BRUNSWICK STEAM ELECTRIC PLANT, UNIT NOS. 1 AND 2
DOCKET NOS. 50-325 AND 50-324/LICENSE NOS. DPR-71 AND DPR-62
RESPONSE TO REQUEST FOR ADDITIONAL INFORMATION REGARDING
REQUEST FOR LICENSE AMENDMENTS - EXTENDED POWER UPRATE
(NRC TAC NOS. MB2700 AND MB2701)

Response to Request For Additional Information (RAI) 10

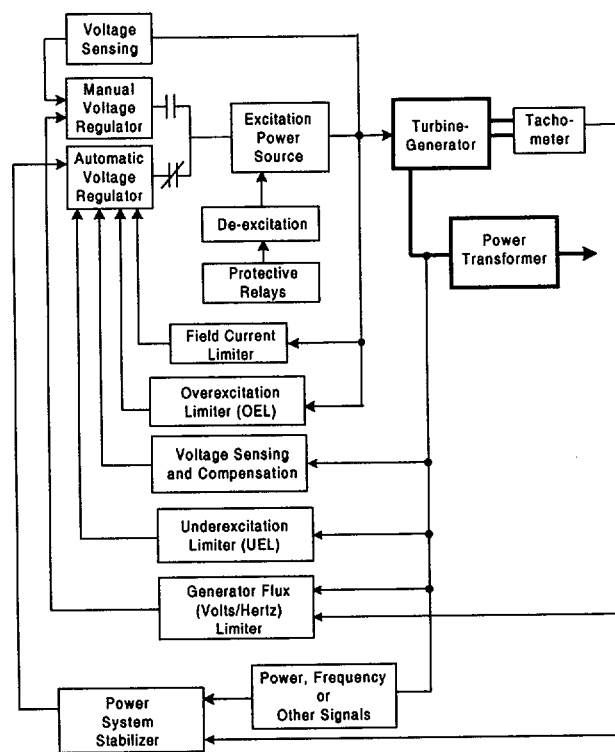
Provide in detail the damping of the post-transient oscillations of the Power System Stabilizer including the schematics. The response should also show how much reactive power (MVARs) is being provided by the power system stabilizer. Does it use the FACTS technology?

Power System Stabilizer (PSS) is a supplementary control that is input to the excitation system to provide damping to power system oscillations. The inputs are those signals in which the oscillations are observable, such as speed (i.e., frequency) and power. The PSS input has the appropriate phase compensation to modulate field voltage such that torques are generated that are out of phase with those causing the power oscillations. The PSS acts to damp out these oscillations in both normal and contingency conditions. The following provides a simplified schematic of the PSS modification in relation to the existing generator controls.
